UNITED STATES
DEPARTMENT OF THE INTERIOR
BUREAU OF LAND MANAGEMENTNM OIL CONSERVATION
ARTESIA DISTRICT
NMOC
DEC 02 2016
RECEIVEDFORM APPROVED
OMB NO. 1004-0135
Expires: July 31, 2010**SUNDRY NOTICES AND REPORTS ON WELLS**
Do not use this form for proposals to drill or to re-enter an
abandoned well. Use form 3160-3 (APD) for such proposals.5. Lease Serial No.
NMNM68040

SUBMIT IN TRIPLICATE - Other instructions on reverse side.8. Well Name and No.
PARKER DEEP 5 FED COM 39. API Well No.
30-015-3255510. Field and Pool, or Exploratory
SHUGART; STRAWN11. County or Parish, and State
EDDY COUNTY, NM

**Parker Deep Fed 3
30-015-32555
Matador Production Company
November 11, 2016
Conditions of Approval**

Proposed Wellbore

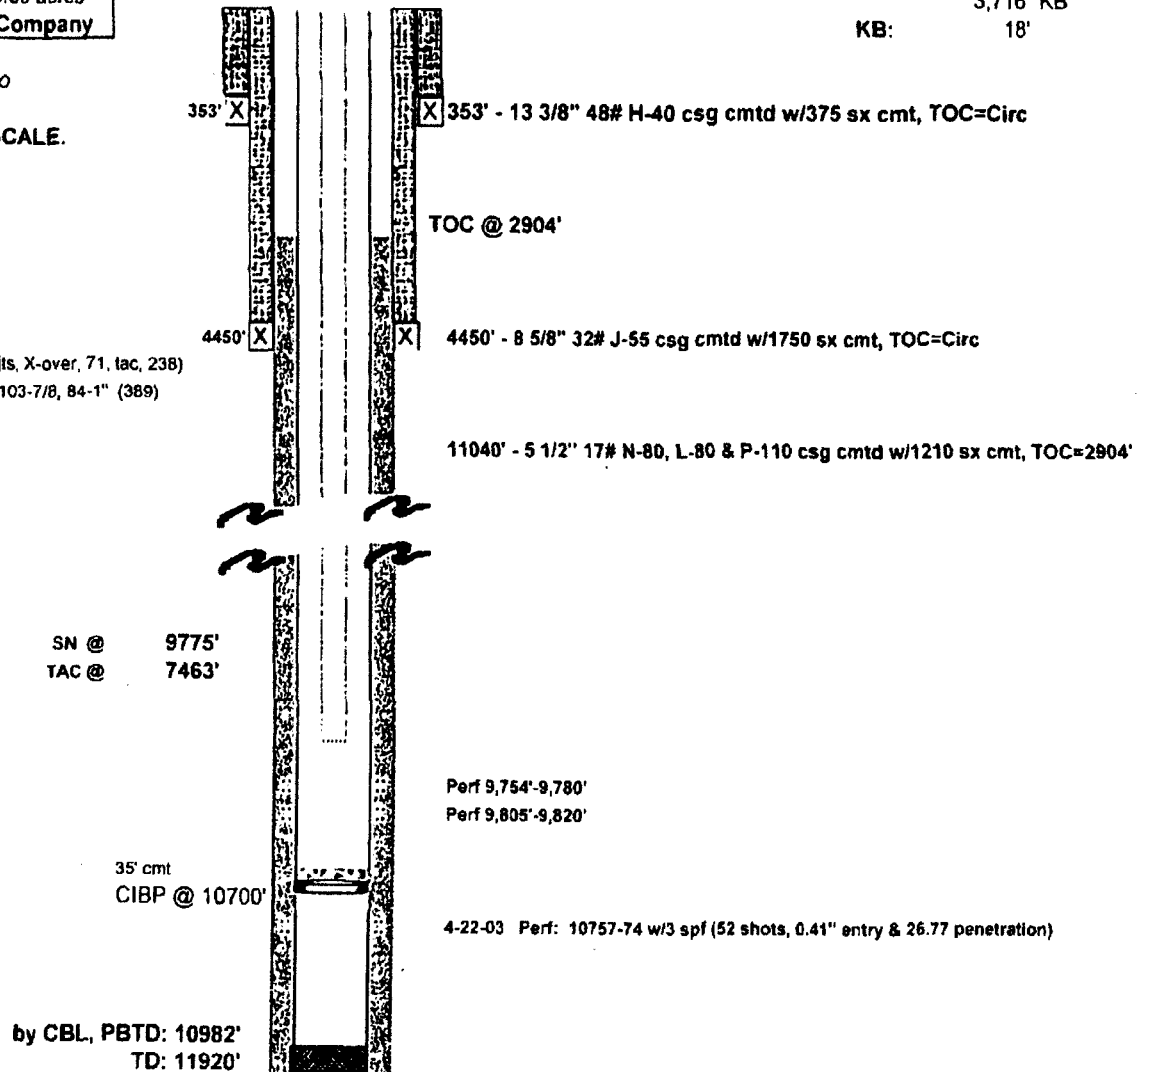
- 1. Operator shall place CIBP at 10,700' (50'-100' above top most perf) and place 35' of Class H cement on top as proposed. WOC and tag.**
- 2. Must conduct a casing integrity test before perforating and fracturing. Submit results to BLM. The CIT is to be performed on the production casing to max treating pressure. Notify BLM if test fails**
